# **Validation Opinion for Post Registration Changes**

Report for:  
M/s CLP Wind Farms (Khandke) Private  
Limited

CDM project for  
“Roaring 40s Wind Farms (Khandke)  
Private Limited - Phase II”  
(UNFCCC ref: 3298)

LRQA Reference : CDM-MUM-0061834  
Date : 24/01/2013

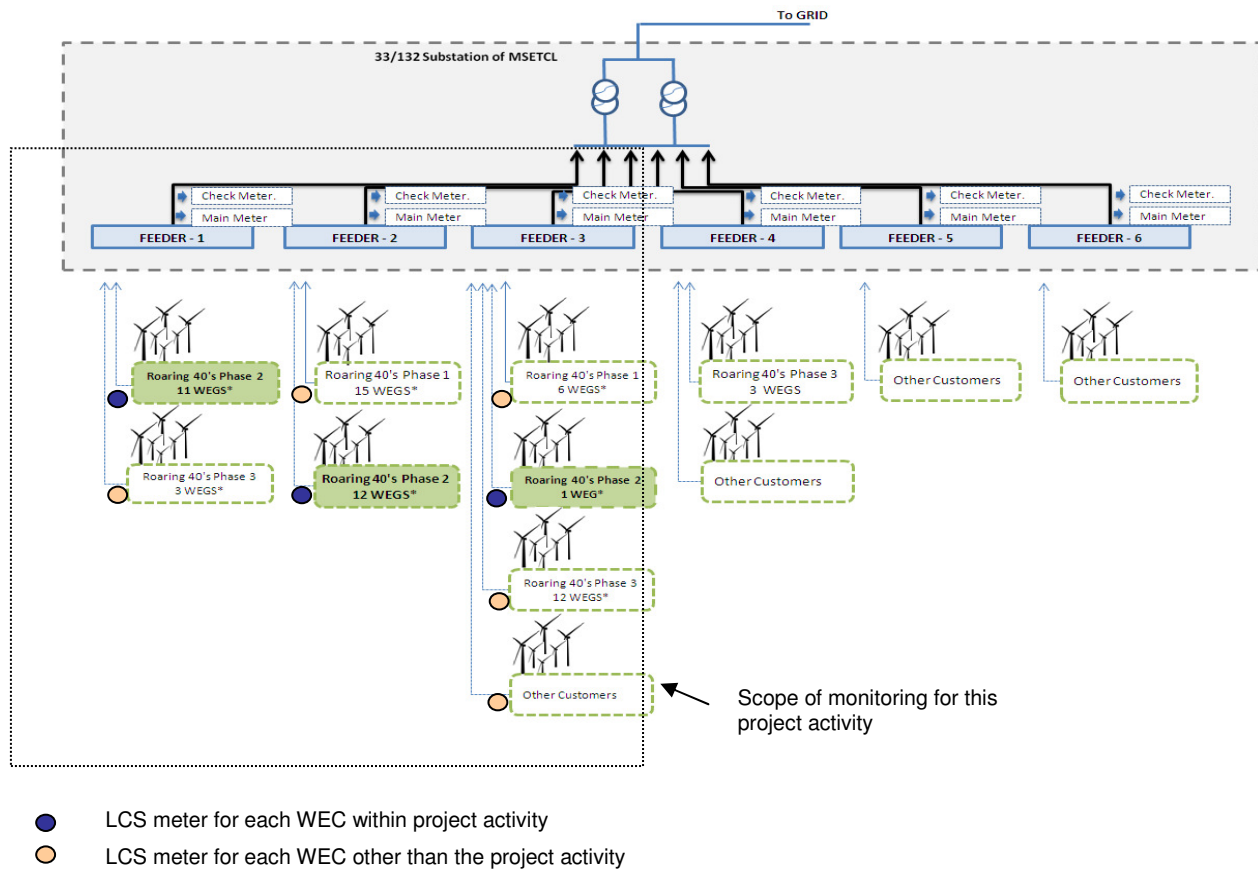
Further in section B.7.2 a line diagram and apportioning procedure is included in the revised monitoring plan for clarity and transparency. Based on site assessment and verification of documents, the team confirms that the provided line diagram and the apportioning procedure reflects the actual monitoring practices and procedures. The organisation structure, roles and responsibility related to monitoring of the project activity, is further elaborated in the section B.7.2 of the proposed revised monitoring plan. The proposed change brings clarity and also reflects actual situation and hence acceptable to the verification team.

The electricity export to the grid and import from the grid, from the WECs connected to feeder1, feeder 2 and feeder 3 is measured through the main and check meters installed at the 33kV side of the Substation. The above line diagram indicates the location of the feeders at the substation and the local control system (LCS) meters at the WECs. Joint Meter Readings (JMR) of the main and check meter is carried out on a monthly basis in presence of the representatives of the Enercon (the O&M contractor) & the state electricity utility (MSEDCL). The JMR gives both the "export" and "import" of the electricity to/ from the grid, which forms the basis on which the utility makes the payment to the project proponent. Electricity export and import for feeder 1, feeder 2 and feeder 3 is denoted as follows;
